ADDENDUM NO. 2

PROJECT TITLE: REPLACEMENT OF ROUTE 7 OVER NORWALK RIVER (BRIDGE NO. 02029)

PROJECT NO. 117-157
DRAWING NO. S-01
SHEET NO. 05.02.A2

DRAWING TITLE: SLAB PLAN

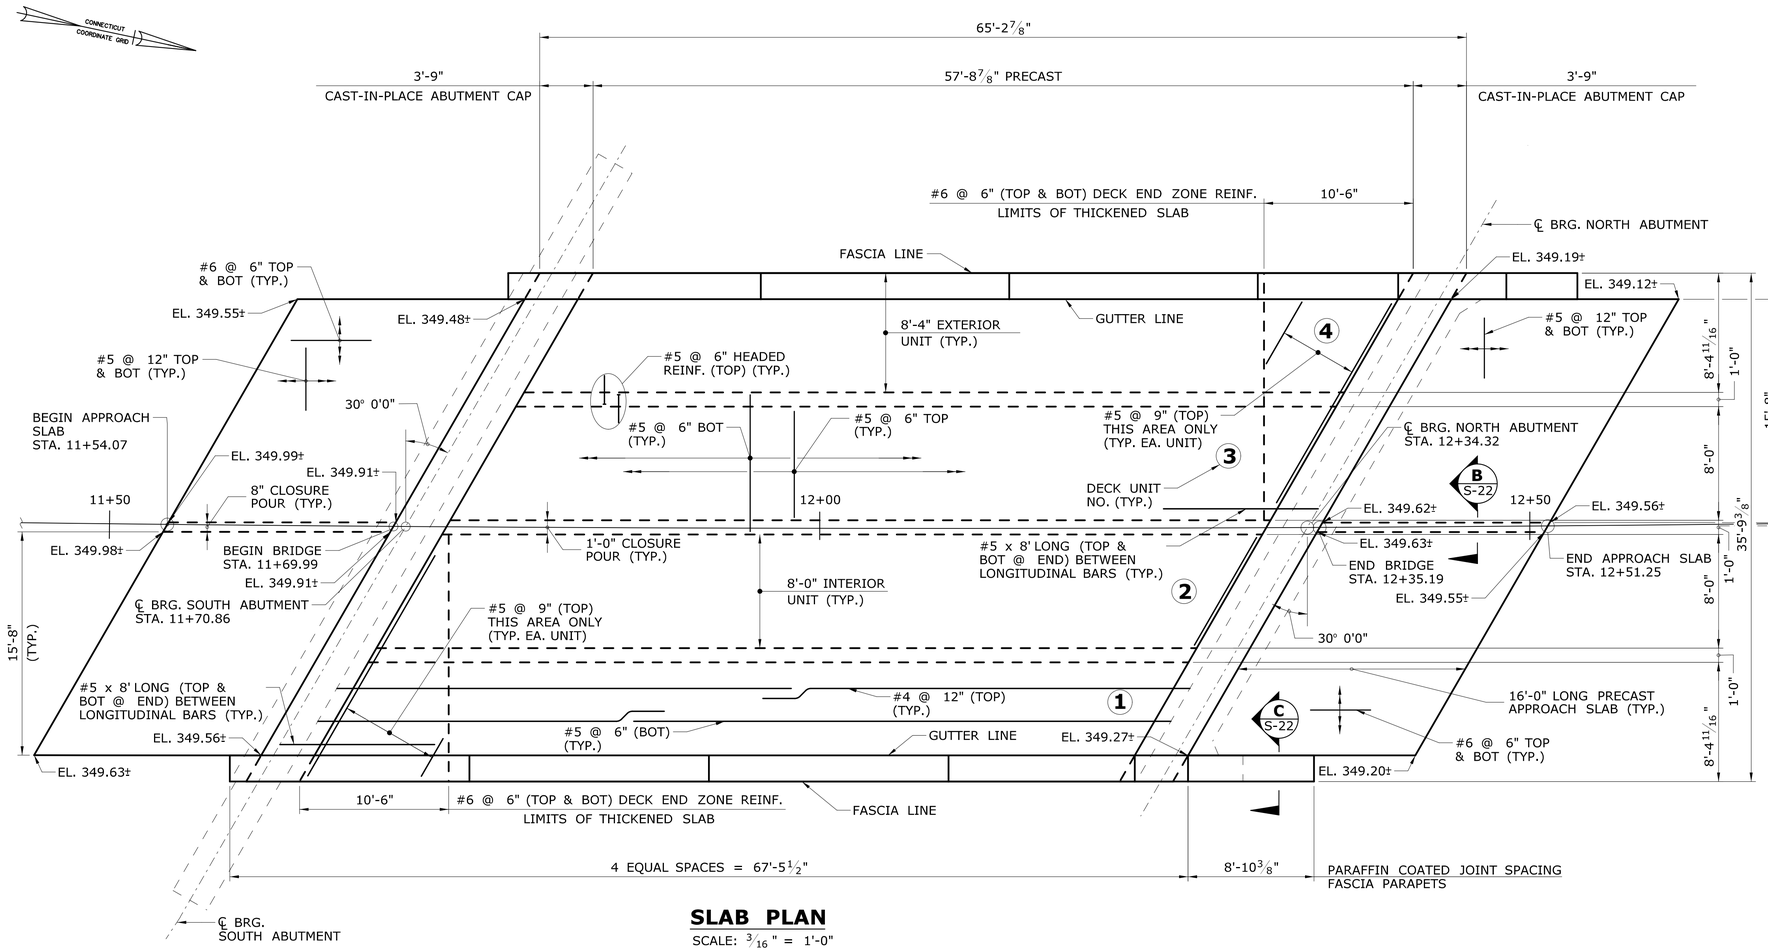
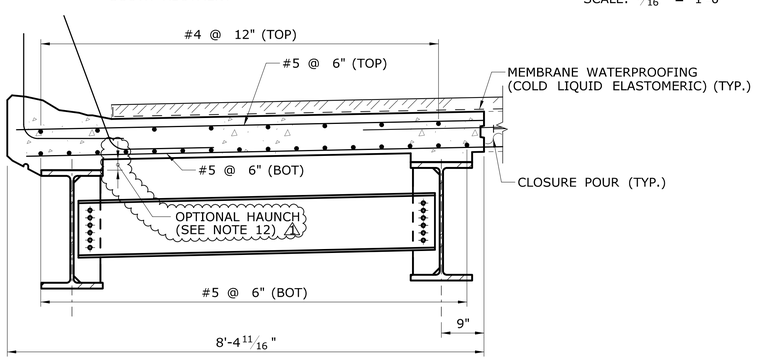
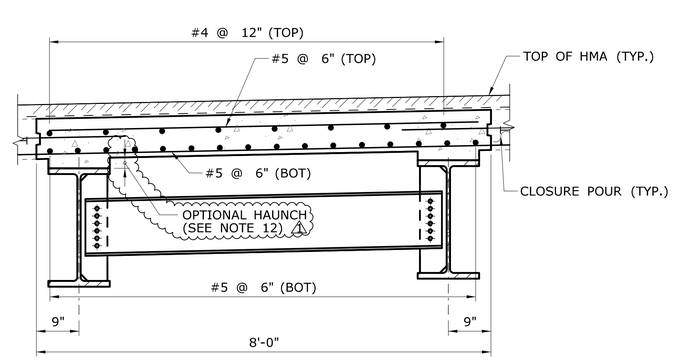
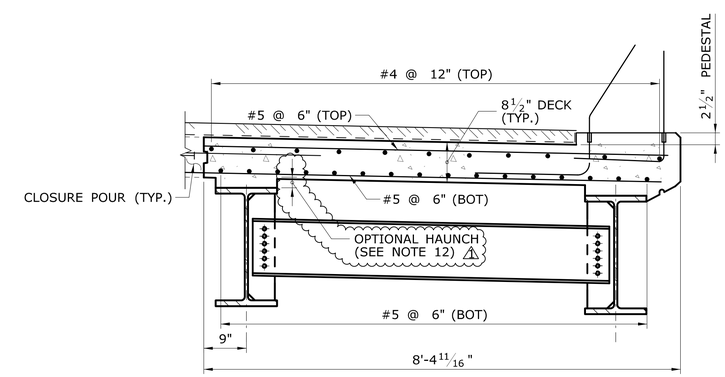
REV.	DATE	REVISION DESCRIPTION	SHEET NO.
1	3/24/15	ADDENDUM NO. 2 - ADDED HAUNCH CALLOUT & NOTE	05.21

6. FOR DETAILS OF PARAFFIN COATED JOINTS, SEE DWG. S-22.
7. FOR CLOSURE POUR DETAIL, SEE DWG. S-21.
8. FOR CLOSURE POUR REINFORCEMENT DETAILS SEE DWG. S-22.
9. MEMBRANE WATERPROOFING (COLD LIQUID ELASTOMERIC) SHALL BE APPLIED TO ENTIRE DECK AND APPROACH SLAB SURFACE, INCLUDING 3" RISE ON FACE OF PARAPET CURB.
10. FOR DETAILS OF PARAPET REINFORCING AT EAST AND WEST FASCIA SEE DWG. S-22.
11. NO VEHICULAR TRAFFIC WILL BE ALLOWED ON THE SUPERSTRUCTURE UNLESS THE LONGITUDINAL CLOSURE POURS ARE CURED FOR A MINIMUM TIME AND THE COMPRESSIVE STRENGTH SPECIFIED IN SPECIAL PROVISION IS ACHIEVED.
12. HAUNCH SHOWN IS OPTIONAL. THE CONTRACTOR MAY CHOOSE TO FABRICATE THE PRECAST SUPERSTRUCTURE UNITS WITHOUT HAUNCHES AT NO ADDITIONAL COST TO THE DEPARTMENT. THE CONTRACTOR IS RESPONSIBLE FOR MAKING ANY AND ALL NECESSARY ADJUSTMENTS, AND SHALL INDICATE THESE ON THE SHOP DRAWINGS. 1

DRAWING TITLE: SLAB DETAILS SHEET 1 OF 2

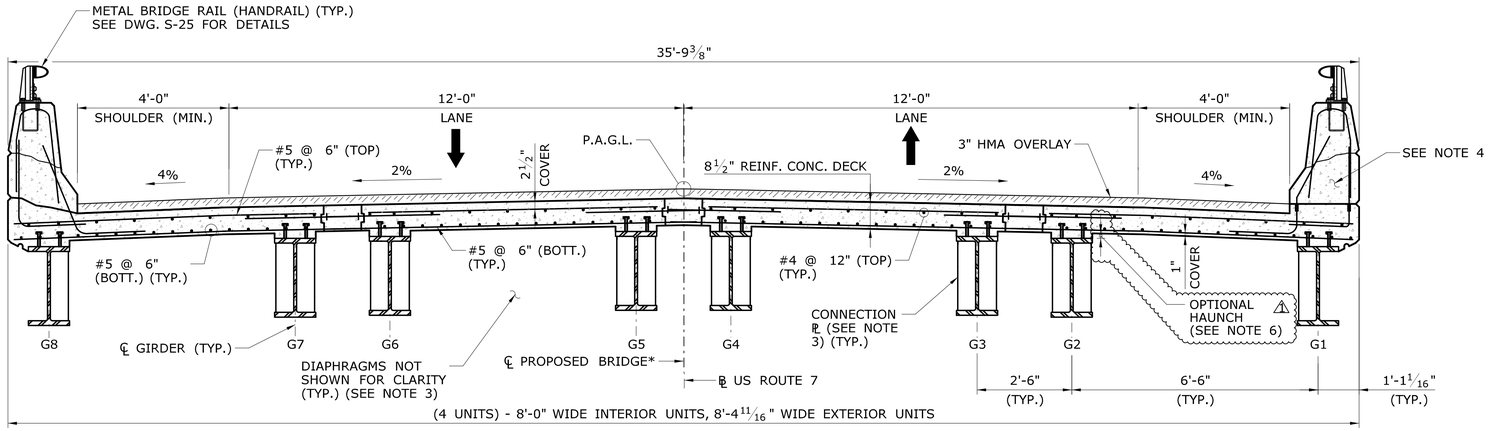
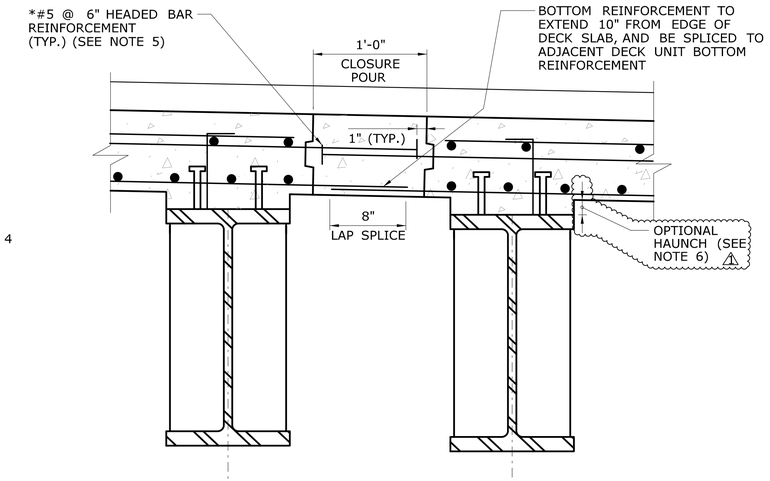
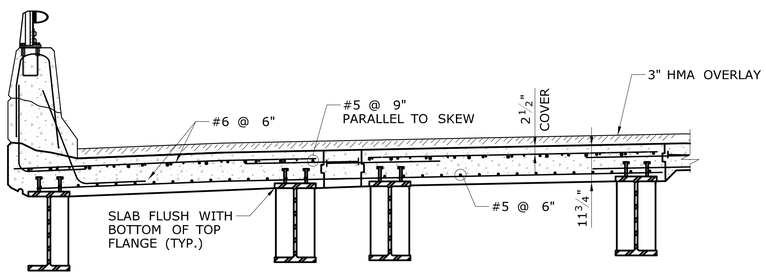
REV.	DATE	REVISION DESCRIPTION	SHEET NO.
△1	3/24/15	ADDENDUM NO. 2 - ADDED HAUNCH CALLOUT & NOTE	05.22

1. ALL REINFORCEMENT IN THE DECK SHALL BE EPOXY COATED AND SHALL BE PAID UNDER ITEM, "PRECAST PRECOMPRESSED CONCRETE/STEEL COMPOSITE SUPERSTRUCTURE".
2. FOR ADDITIONAL SLAB DETAILS, SEE DWGS. S-20 AND S-22.
3. FOR DETAILS OF CONNECTION PLATES AND DIAPHRAGMS SEE DWG. S-19.
4. FOR DETAILS OF PARAPET REINFORCEMENT SEE DWG. S-22.
5. FOR FURTHER DETAILS OF HEADED BAR REINFORCEMENT IN CLOSURE POUR SEE DWG. S-22.
6. HAUNCH SHOWN IS OPTIONAL. THE CONTRACTOR MAY CHOOSE TO FABRICATE THE PRECAST SUPERSTRUCTURE UNITS WITHOUT HAUNCHES AT NO ADDITIONAL COST TO THE DEPARTMENT. THE CONTRACTOR IS RESPONSIBLE FOR MAKING ANY AND ALL NECESSARY ADJUSTMENTS, AND SHALL INDICATE THESE ON THE SHOP DRAWINGS. (△1)

DRAWING TITLE: SLAB DETAILS SHEET 2 OF 2

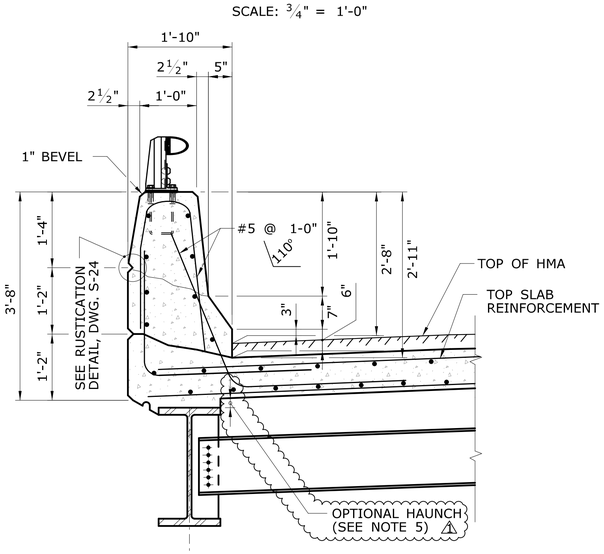
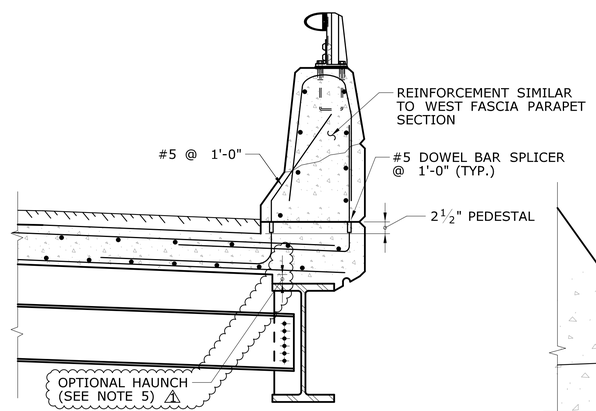
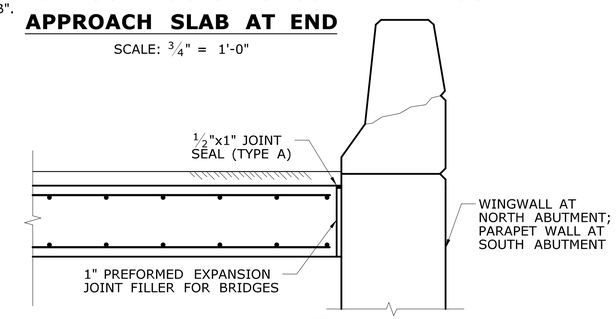
REV.	DATE	REVISION DESCRIPTION	SHEET NO.
1	3/24/15	ADDENDUM NO. 2 - ADDED HAUNCH CALLOUT & NOTE	05.23

1. ALL REINFORCEMENT IN DECK SHALL BE EPOXY COATED.
2. FOR STEEL NOTES, SEE DWG. S-19.
3. FOR PROFILES, SEE DWG. S-03.
4. FOR ADDITIONAL SLAB DETAILS SEE DWGS. S-20 AND S-21.
5. HAUNCH SHOWN IS OPTIONAL. THE CONTRACTOR MAY CHOOSE TO FABRICATE THE PRECAST SUPERSTRUCTURE UNITS WITHOUT HAUNCHES AT NO ADDITIONAL COST TO THE DEPARTMENT. THE CONTRACTOR IS RESPONSIBLE FOR MAKING ANY AND ALL NECESSARY ADJUSTMENTS, AND SHALL INDICATE THESE ON THE SHOP DRAWINGS.
